Final Drainage Report

Meadowbrook Park El Paso County, Colorado

PCD File No.: PUDSP208
SF-21-025

Prepared: March 18th, 2021
Revision 1: June 2, 2021
Revision 2: July 14, 2021
Revision 3: September 30, 2021
Revision 4: February 3, 2022

Rock Chute Design - Cut/Paste Plan

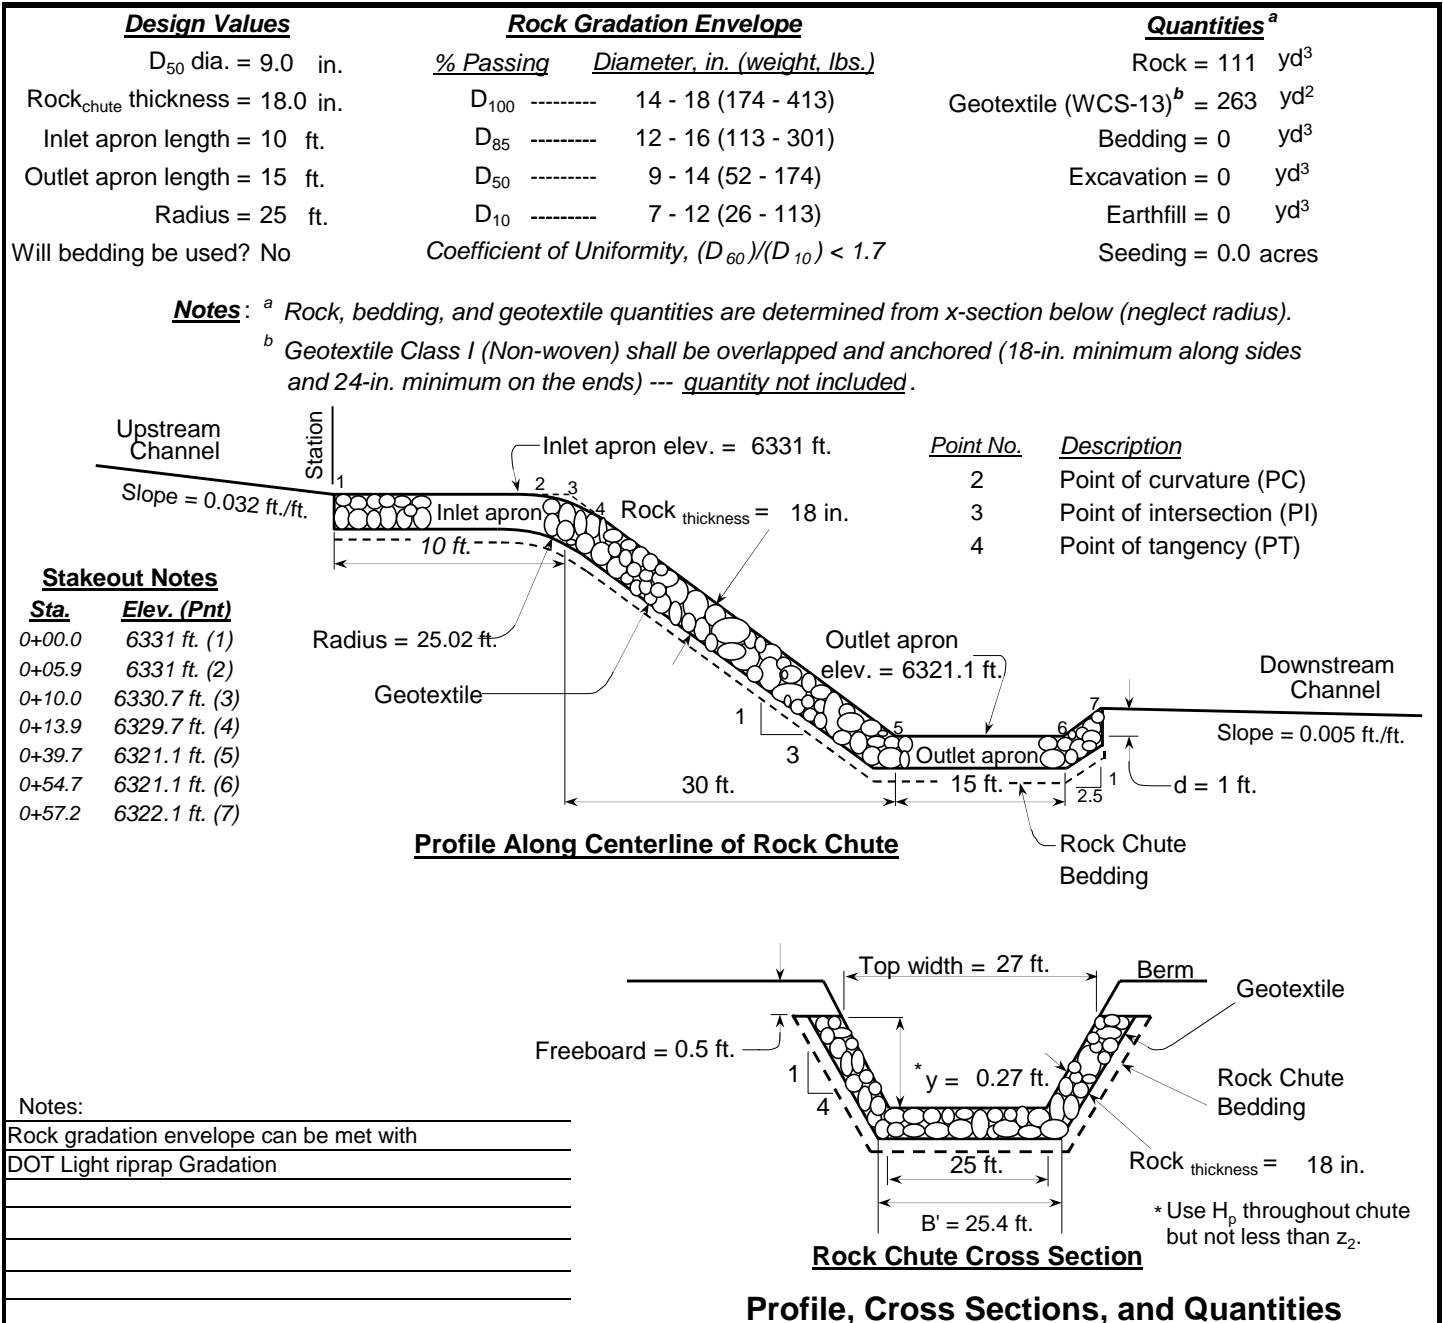
Review 2 comment:
Please identify the synthetic mat and riprap being used at the channel and ditch

Review 3 comment:
unresolved.

DETENTION BASIN OUTLET STRUCTURE DESIGN

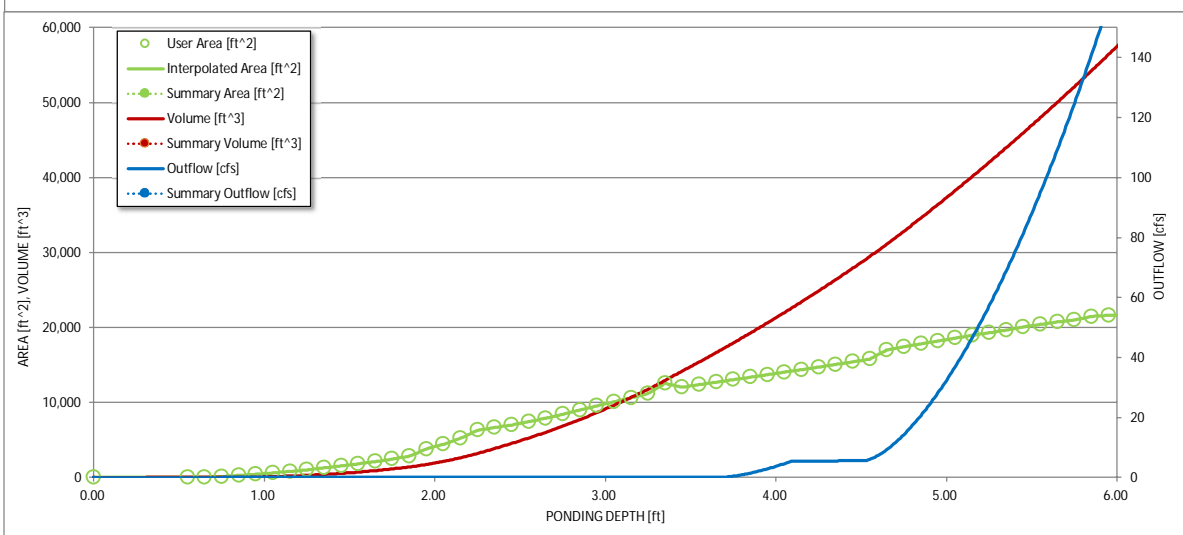
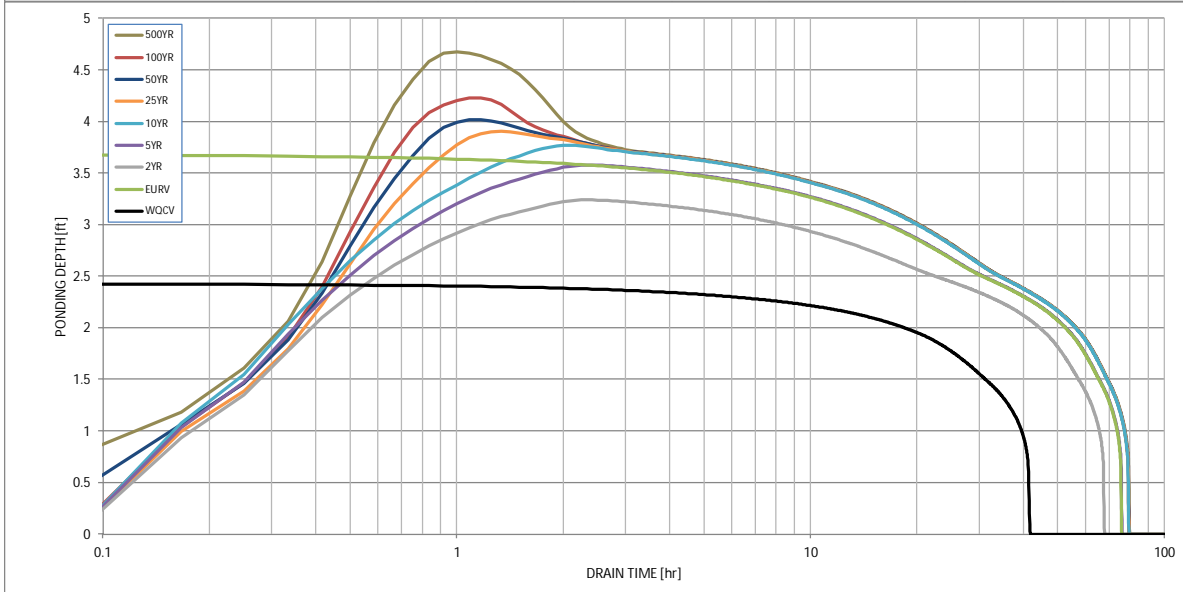
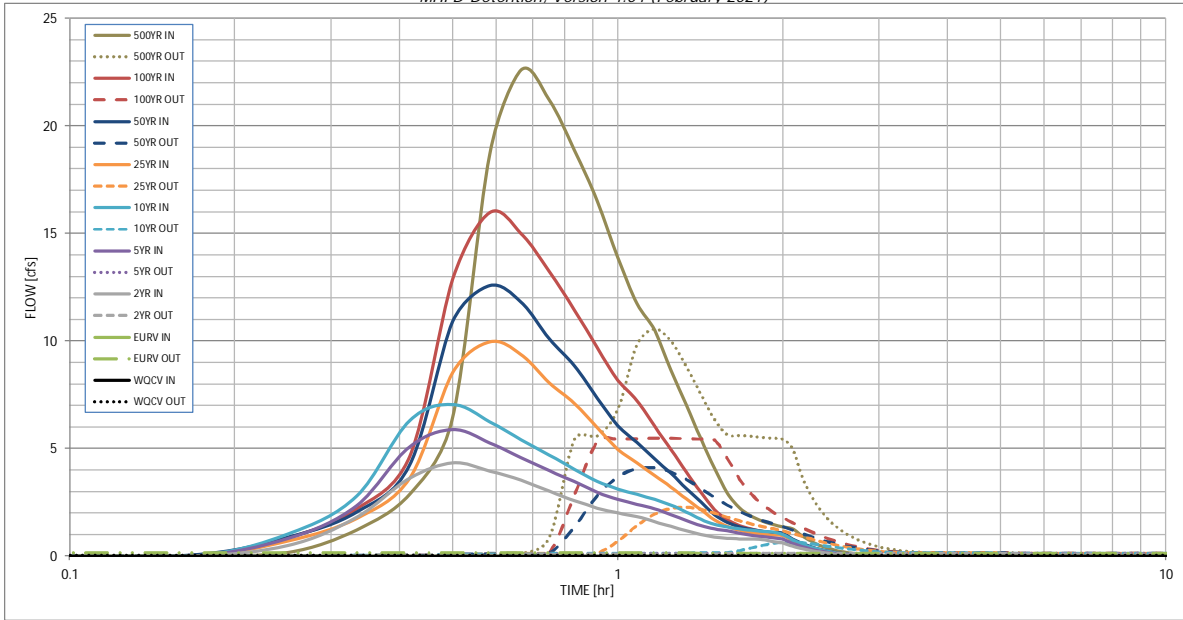
review 1 comment: Please adjust so that the released flow is equal to or less than pre-development
Review 2: Unresolved.
Review 3: unresolved. Please address comment above. It appears that if you slightly increase the overflow weir front edge height it would alleviate this issue.

Engineering Profile - STRM LINE A (Meadowbrook StormCAD.stsw)

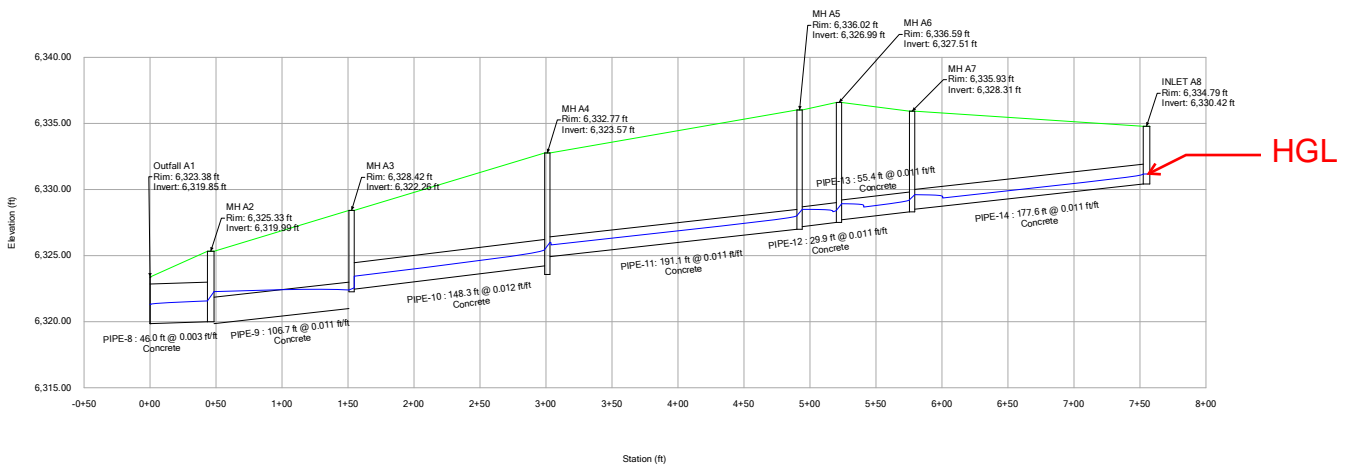
This storm line does not reflect what is shown on the CD's. Please update the CD's or drainage report so that they are consistent with each other.
